Board of Zoning Appeals Agenda

Application for Variance:
9678 Montgomery Road
(Hamilton County Parcel # 6030002003300)

June 20, 2023
Staff Report

Application for Variance: *7933 Cooper Road*

SHEET TITLE
ARCHITECTURAL SITE PLAN

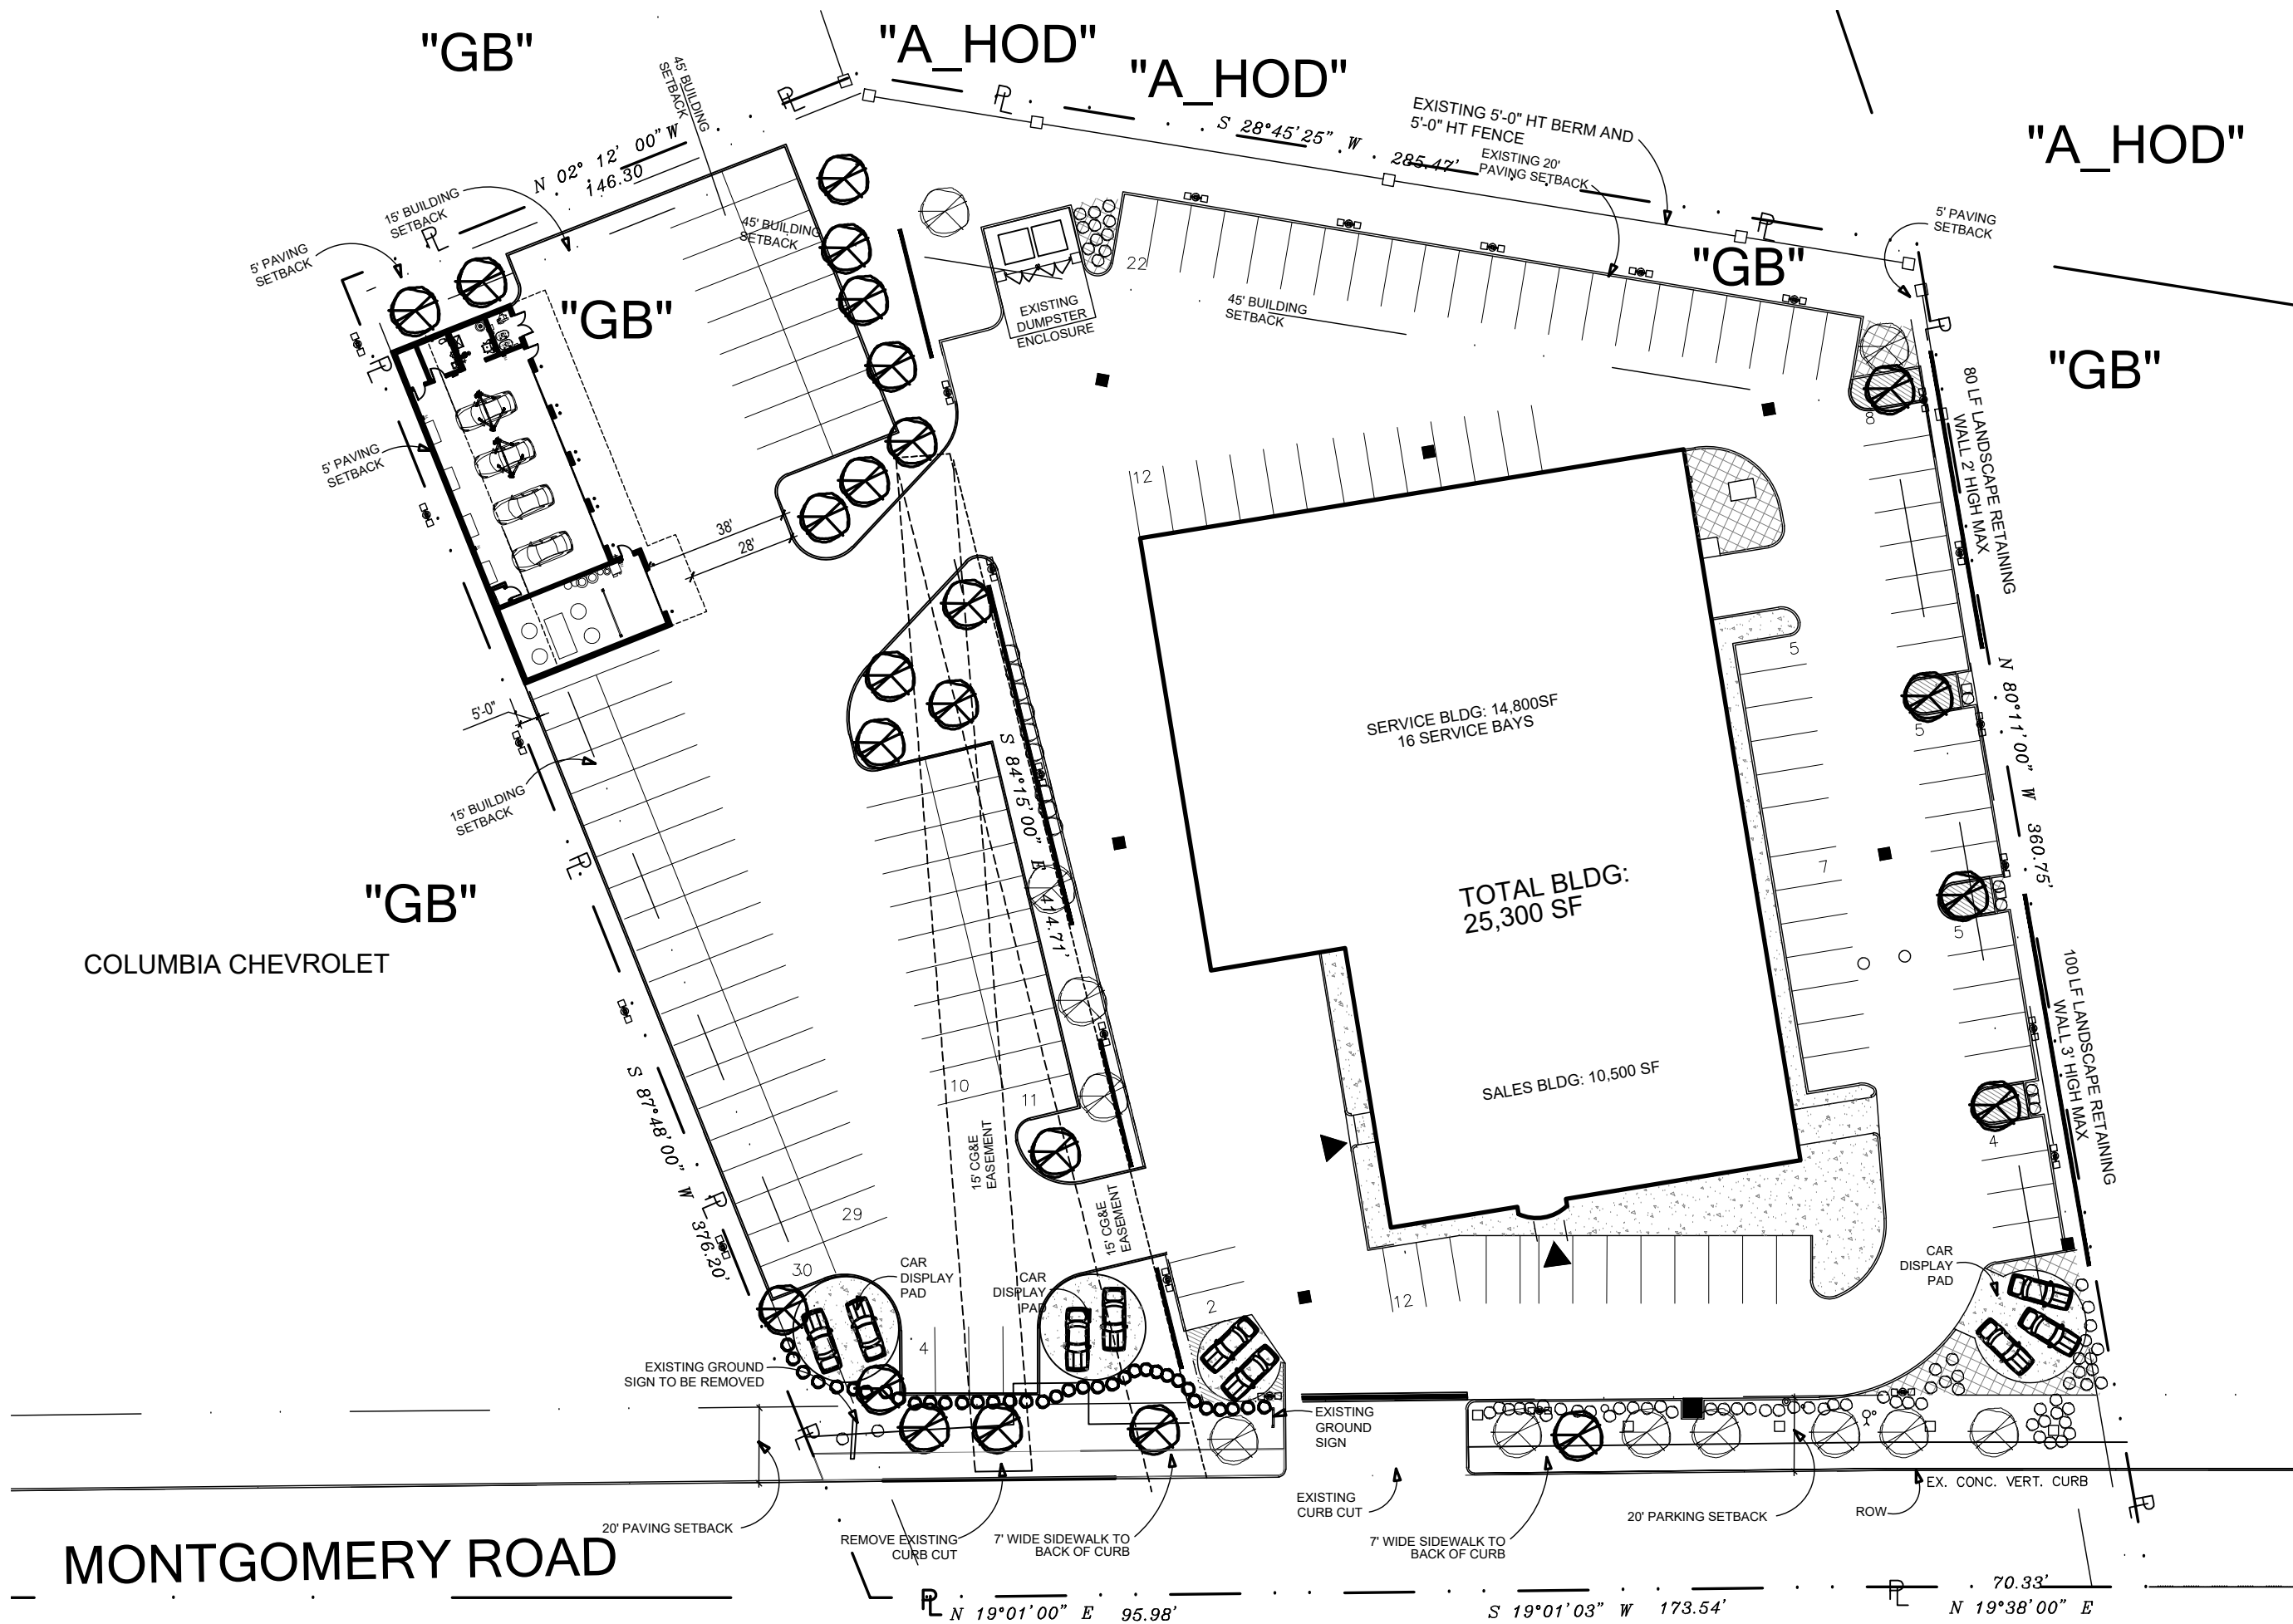
Staff believes that the based on trying to be the least impactful to adjacent residential uses and car display and parking area onsite, and trying to minimize visibility from Montgomery Road creates a practical difficulty that makes it challenging to build on the lot without some variance in regards to side-yard setbacks. Staff does not believe that the neighborhood would be negatively impacted by granting the variance as the applicant is locating closer than permitted by code to a very similar use on the northern parcel.

Approving the variance to allow for side yard setbacks of 5' in accordance with the accessory service structure as shown in plans dated May 25, 2023 where 10' side yard setback is required could be justified by criteria # 1, 3, 4, 5, 7, 8, 9 and 10.

The owner is requesting moving the building up to the existing edge of pavement on the north side that is 5' from the property line. The current building setback limits is 15'-0". The reason for the request is to provide as much space as possible for access and turning at the wash bay portion of the proposed building. Moving the building 5' from the property line provides approximately 38" of clear space. Locating the building within the limits of the 15' building setback reduces this distance to approximately 28'.

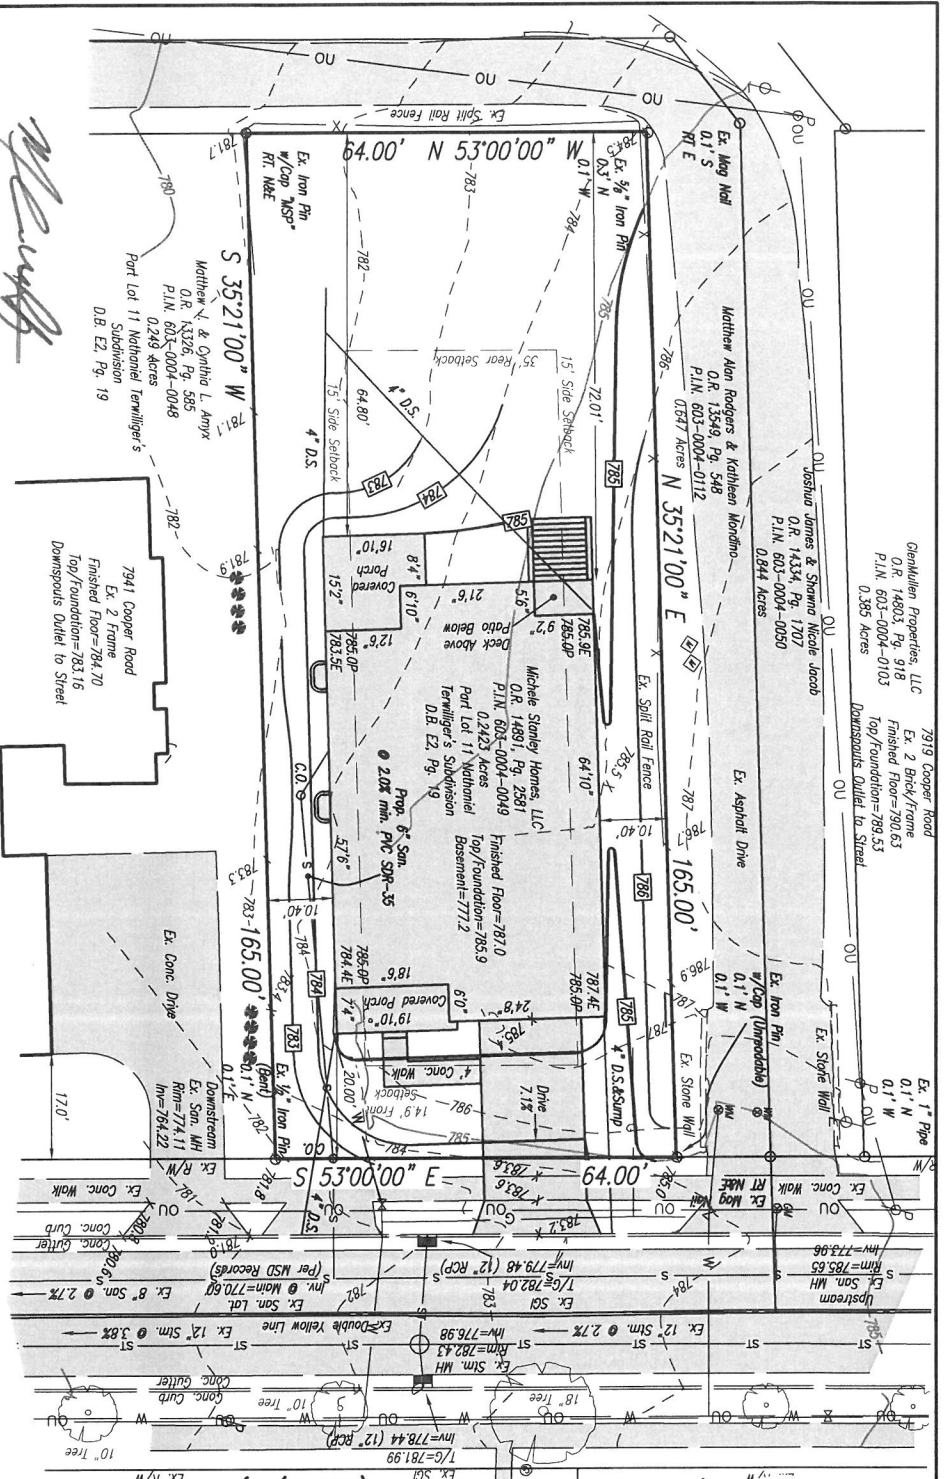
Staff believes that the narrow lot width and reduced overall lot size for this property creates a practical difficulty that makes it challenging to build on the lot without some variance in regards to side-yard setbacks. Staff does not believe that the neighborhood would be negatively impacted by granting the variance as the applicant must adhere to the standards required in the Heritage Overlay District. In addition, the Landmarks Commission supports the proposed new single family dwelling.

Approving the variance to allow for side yard setbacks of 10.4' in accordance with the house as shown in plans dated May 24, 2023 where 15' side yard setback is required could be justified by criteria # 1, 2, 3, 4, 5, 7, 8, 9 and 10.
